Sespe Creek Overflow Railroad Bridge Repair IFB No. SPBL-2025-01 Questions - Responses to Questions Received between April 30 and May 13, 2025:

Includes questions submitted in writing to SPBL@GOVENTURA.ORG as of 4:00PM on April 30, 2025. Answers are provided as a courtesy to prospective bidders. No additional questions will be received or responded to prior to the close of bidding on May 16, 2025 at 3:00PM.

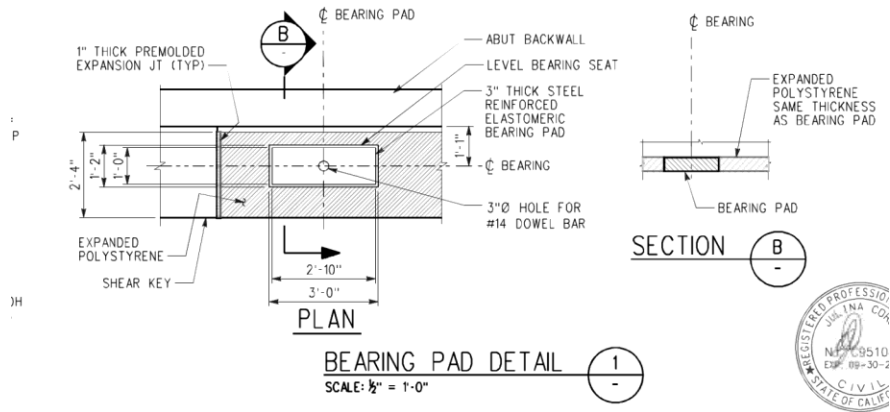
- 1. Our rebar suppliers are having trouble getting the A1035 specified rebar at the curb joint due to the small quantity. Is stainless steel rebar acceptable as a substitute?**

Substitutes will be accepted provided that all other requirements are met. A formal request will need to be submitted for review and to obtain work authorization prior to proceeding.
